RYZ014A

LTE Cat-M1 Cellular Pmod™ Expansion Board
for RYZ014A
Errata

RYZ014A Pmod™ Expansion Board – Errata

Figure 1. RTS0 Pull-up Resistor R1

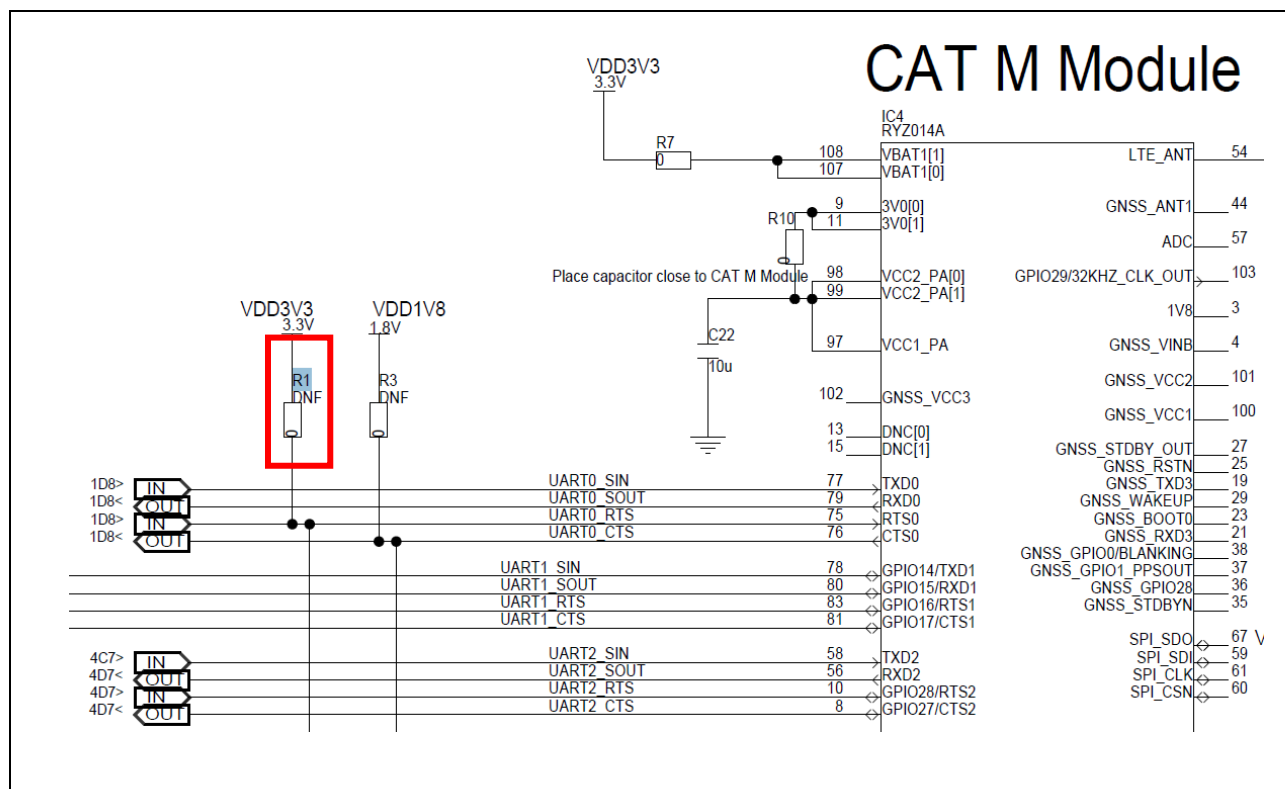
The RTS0 signal (pin 75) of the RYZ014A module should be pulled up to VDD1V8. On the schematic and board the 0R pull-up resistor R1 (DNF) is connected to VDD3V3.

In your own design implementation, ensure that the RTS0 signal is pulled up to 1.8 V if needed. Refer to the *RYZ014A Module Hardware Manual* and *RYZ014A Module Integration Guide* for more details – see resource links in section 3.

Figure 2. Module Power Enable POWER_EN

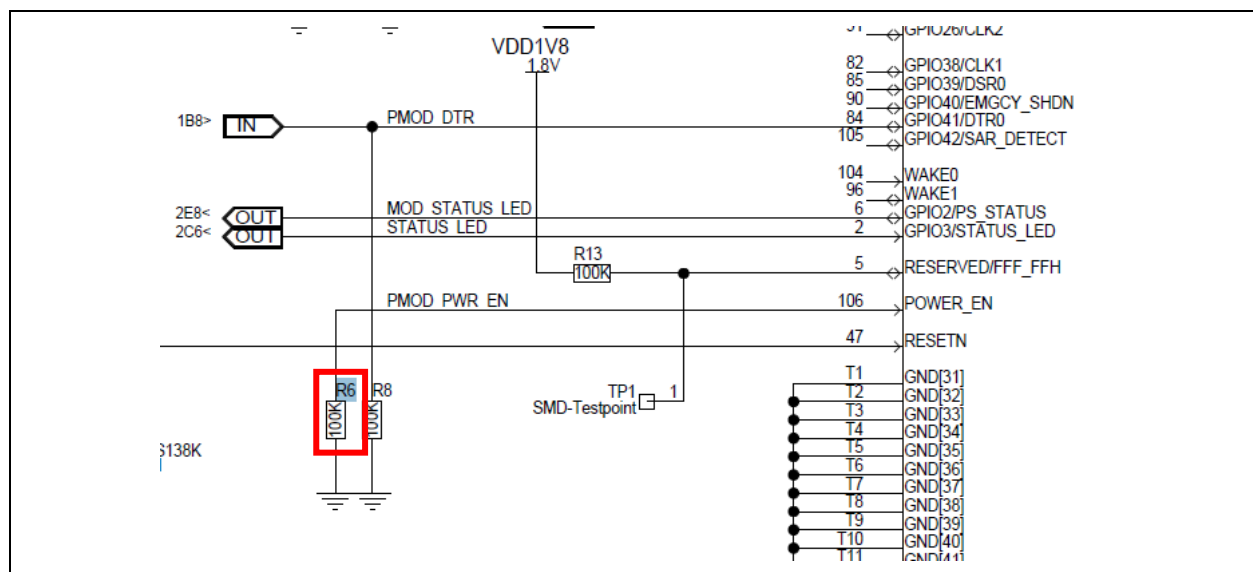
The module POWER_EN signal (pin 106) should be pulled down to GND via a 470K resistor. On the schematic and board a 100K pull-down resistor R6 is used.

In your own design implementation, ensure that this signal is pulled-down via a 470K resistor. Refer to the *RYZ014A Module Hardware Manual* and *RYZ014A Module Integration Guide* for more details – see resource links in section 3.

Figure 3. Reserved Pin GPIO23

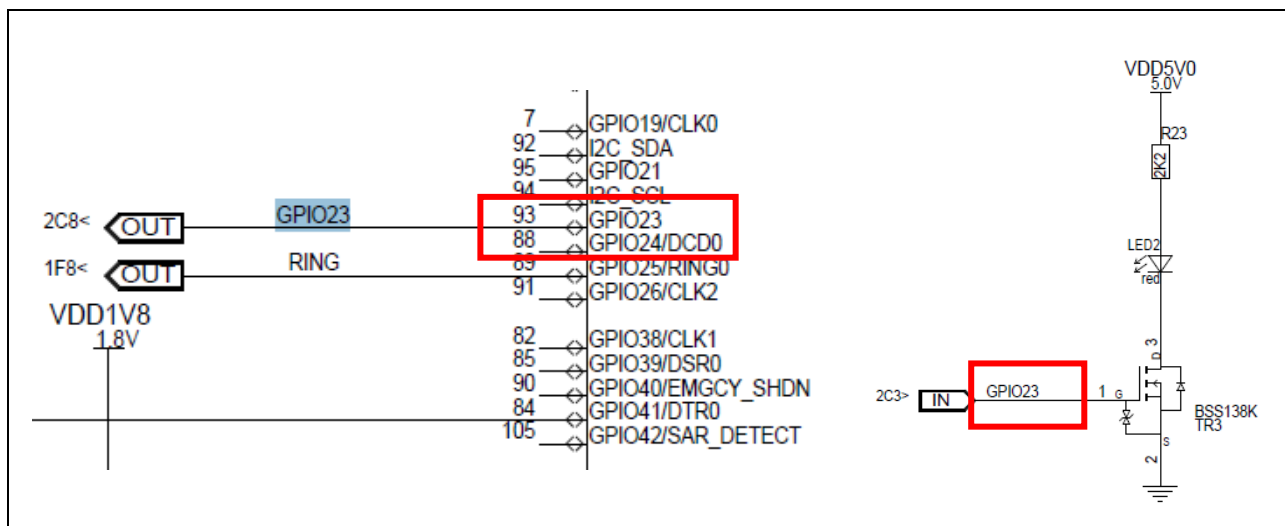
GPIO23 (pin 88) and GPIO24 (pin 93) are reserved pins and should not be used. On the board, GPIO24 (pin 93) is used to drive TR3.

On the schematic, GPIO23 is incorrectly identified as pin 93 and GPIO24 is incorrectly identified as pin 88.

In your own design implementation ensure that GPIO23 and GPIO24 are not connected. Refer to the module hardware manual for more details.
